MPC574xP Default Configuration Update

This Engineering bulletin describes updates for the following default configuration:

Document Number: EB00921
Rev. 0
06/2021

Figure 1 PMC_LVD_MISC DCF record configuration.

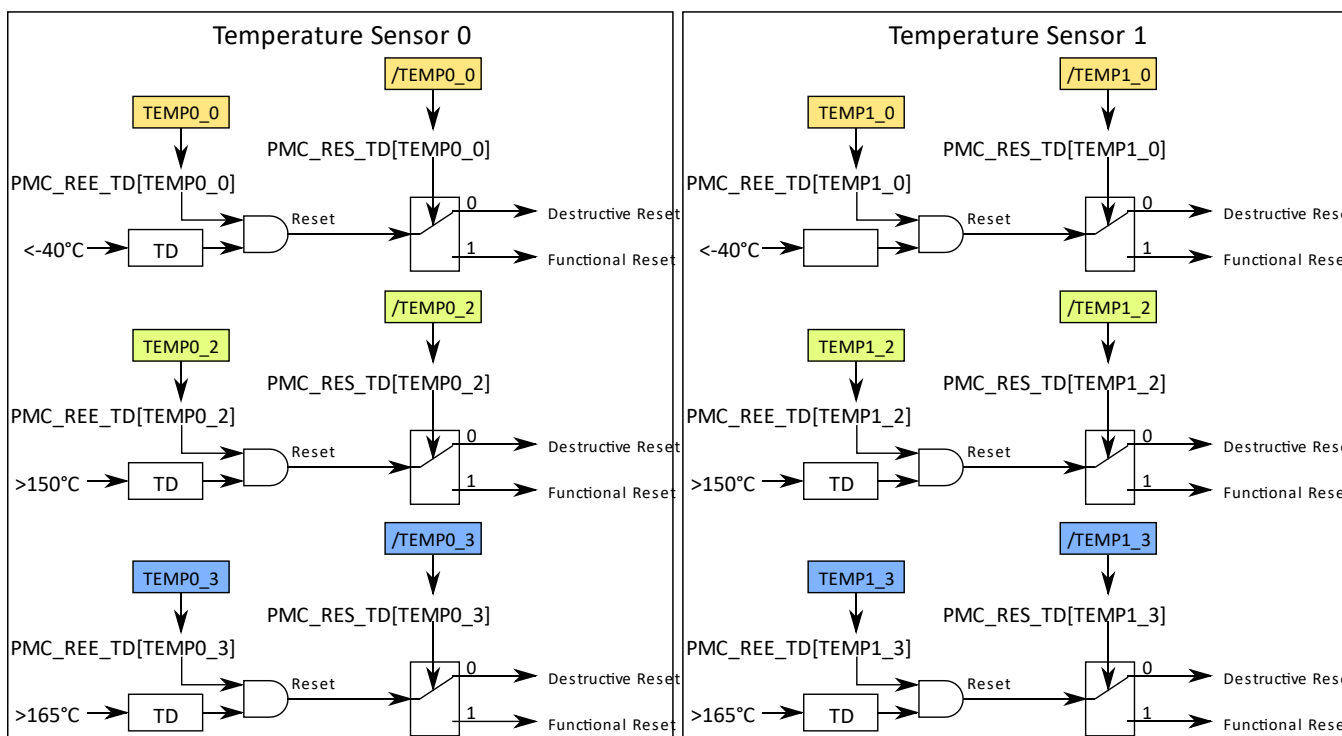
Storing the LVD trimming values into the utest flash memory on the address range 0x0040_00F0 – 0x0040_00FB.

The reason for this update is the possible usage of the PMC_LVD_MISC DCF record for configuration the temperature sensor reaction because this record configure together with the temperature sensor reaction also the LVD trimming values.

The PMC_LVD_MISC DCF record which programs the temperature sensor reset reaction and LVD trimming values are triple voting DCF record. It means that it is programmed by three record where the first content is the direct data, second is the inverted data and the third one is the rotated data. This is the reason why LVD trimming values are stored in this format in the utest flash. By default the temperature sensor reset reaction are disabled.
